# PRODUCT CHANGE NOTIFICATION

### Bourns® Radial Leaded Multifuse® Polymer PTC Resettable Fuses

#### *Changes to Tape and Reel Packaging*

MF1955

Before (Example)	After (Example)	PTC Shape
		Round	
		Square

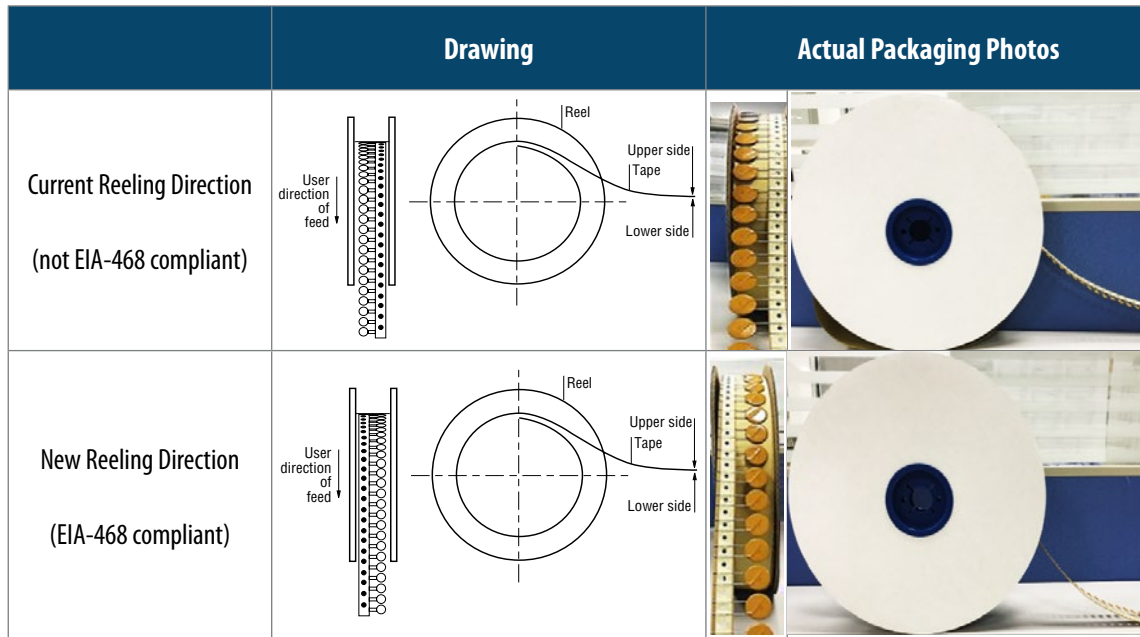
For the Multifuse® models listed in the “Affected Part Numbers” table in this PCN, the total length of the leads will be shortened as shown in the example pictures below. The actual dimension changes will vary between models. However, assuming the components will be removed from the tape and reel packaging by cutting the leads at the tape edge, the form, fit and function of the component will not be affected. Only the length of the scrap lead material remaining in the tape will change. There is no change in the mechanical, electrical or material properties, and the components’ performance and agency recognition remain the same. Changed products can be identified by date
